RE: BZA Application No. 17190

I hereby request that you waive the rule requiring submission of additional information 14 days prior to the hearing and accept for further consideration an amendment to BZA Application No. 17190. I want to amend the variance from the alley setback requirement under subsection 2300.2(b) to allow construction of a garage with a setback of 7'-6" from the centerline of the alley.

BZA
Case No. 17190
Exhibit No. 29

EXCAVATION AREA - ORIGINAL PLAN

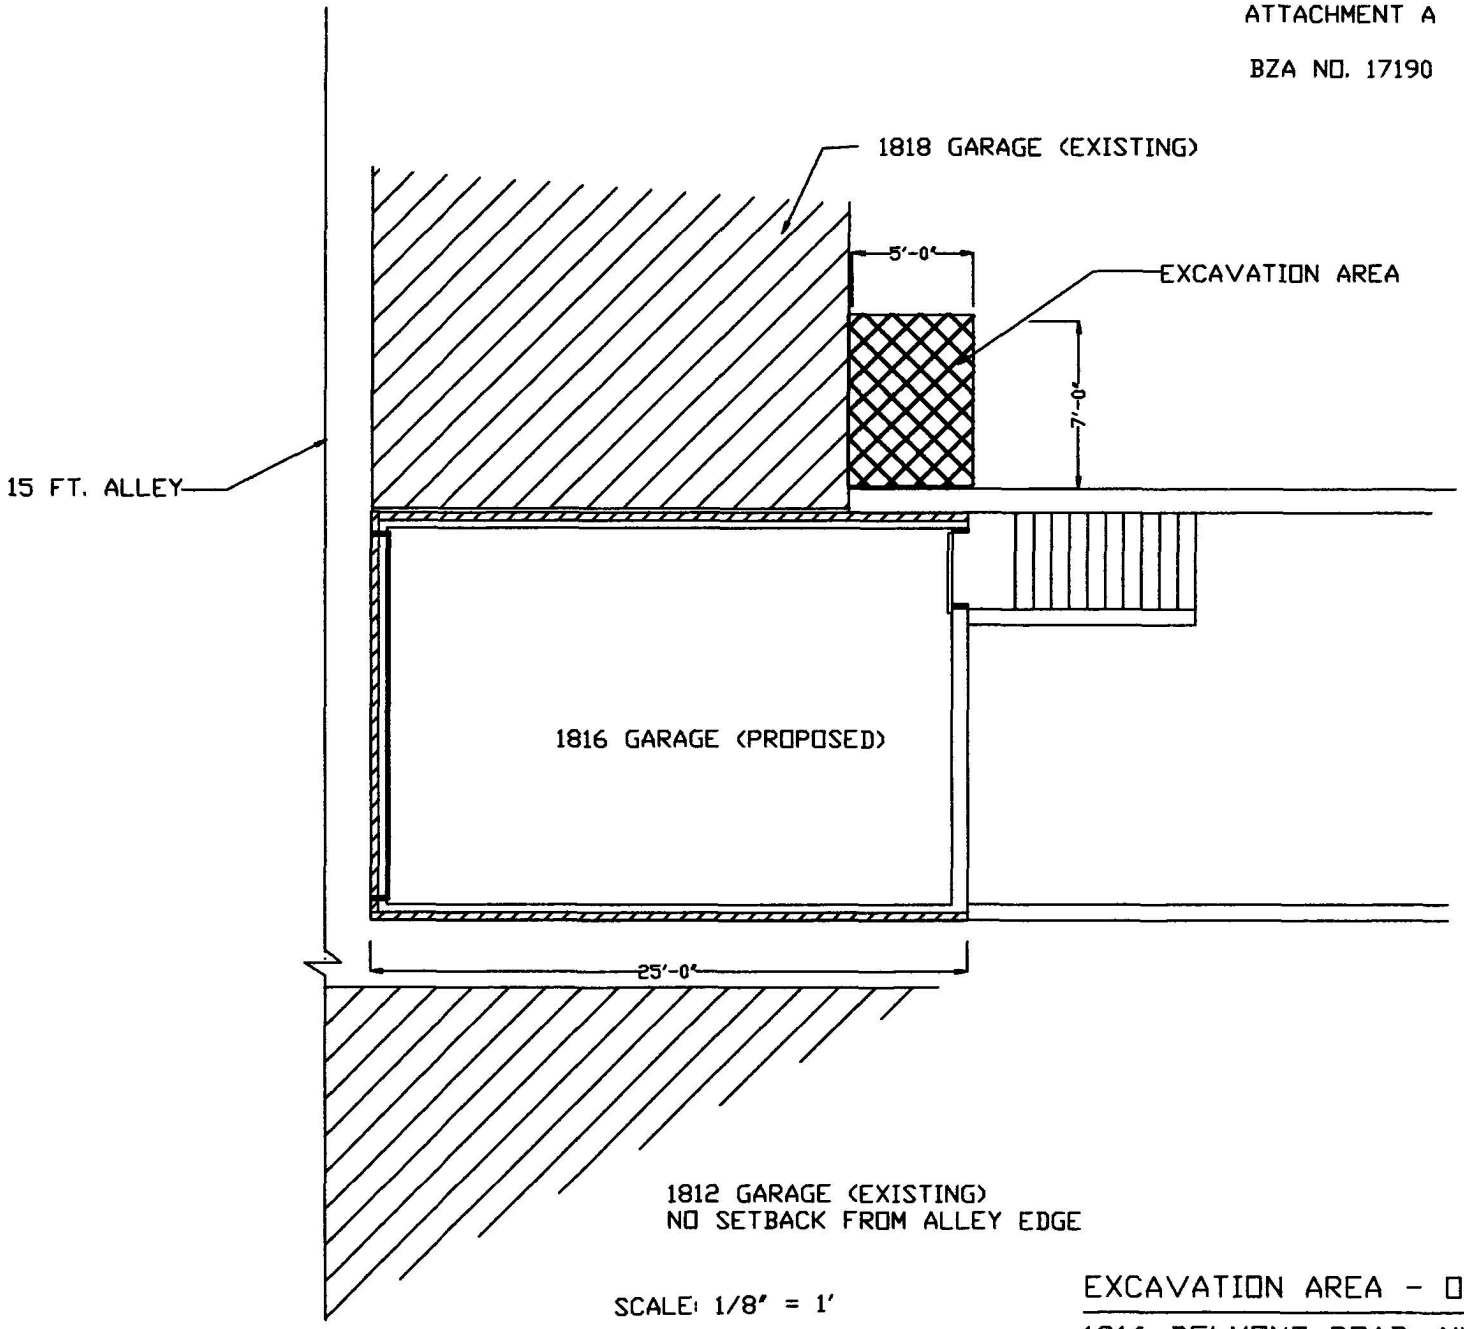
The extreme grade difference between our yards added to the 4 ft. of additional excavation down to the alley grade means that in this 5 ft. area, the retaining wall between our yards will have to be 12 ft. high! The engineers have all agreed that the new footer for such a high wall will have to extend at least 60% of the wall height back under the higher grade. In addition, to reach the frost level, the footer will have to be 2'-6" below the alley grade. This would mean that for this 5 ft. length, the contractor must excavate 7 ft. back into my neighbor's yard and go down 14'-6". (Attachment A shows the excavation area in the original plan; Attachment B shows the wall cross-section in the original plan.)

OVERVIEW PLAN - OPTION 1

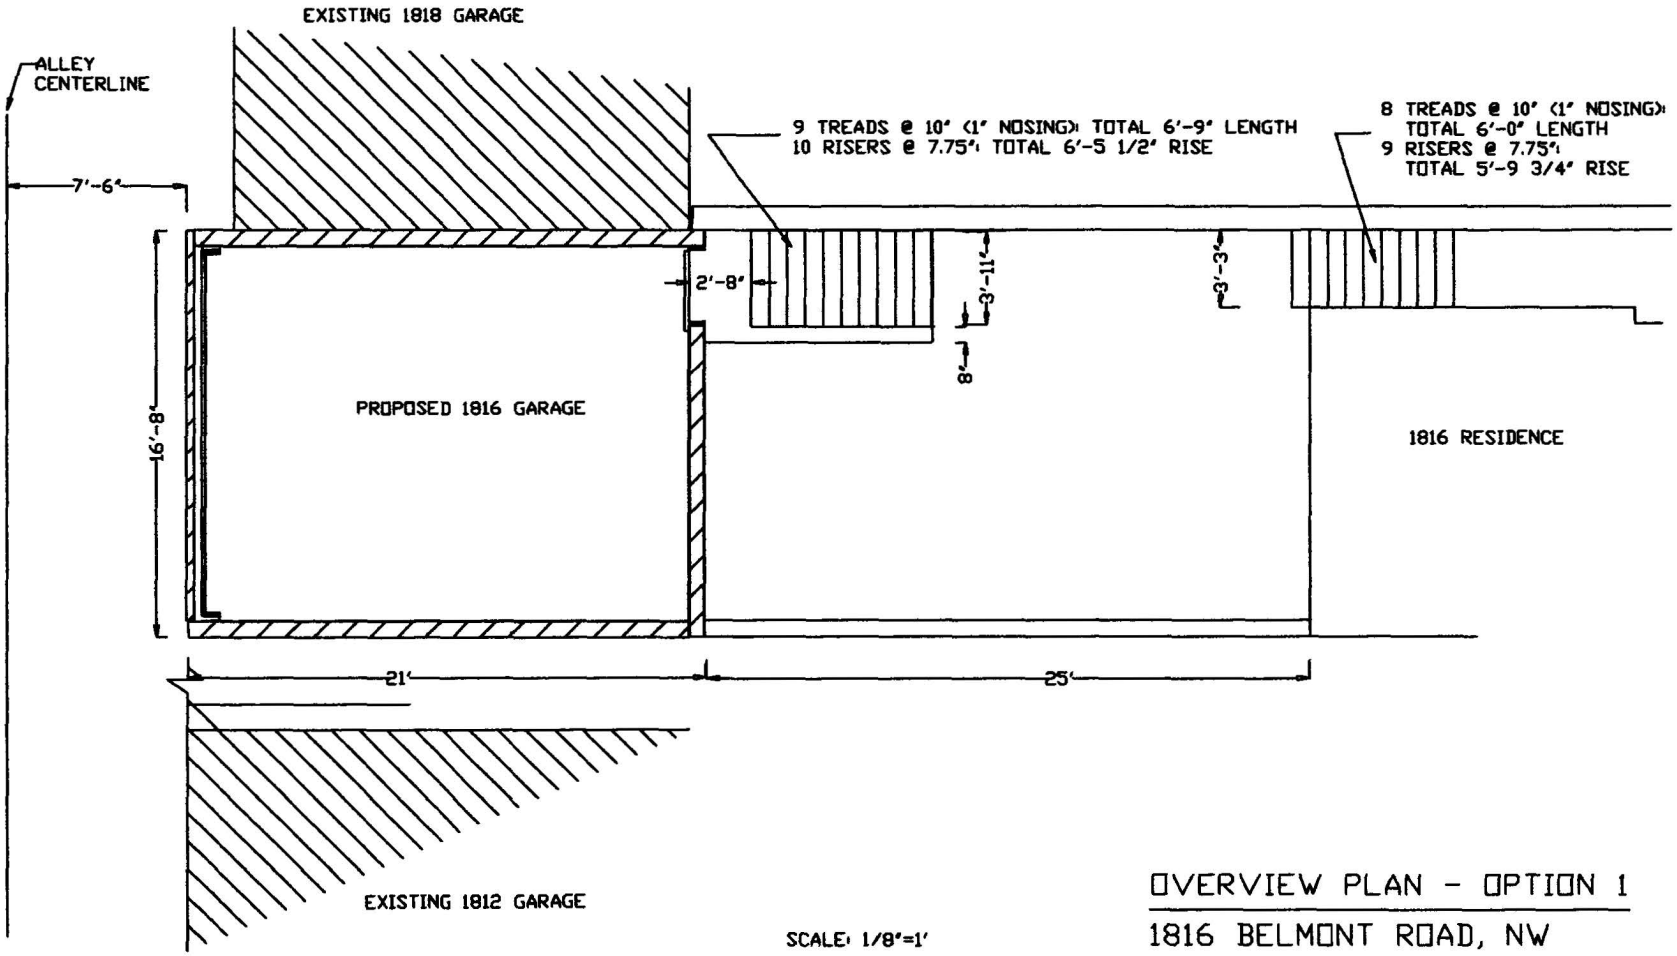
The first would be a garage 21 ft. long (19 ft. interior length) with a straight rear wall that would act as a retaining wall in two directions -- to the north and to the west. (Attachments C and D show the design overview and plat for Option 1.) The second would have a two-step wall and use the stairway as a retaining wall to the north and to the west. (Attachment E and F show the design overview and plat for Option 2.) I would like the option of selecting one based on its cost of construction.
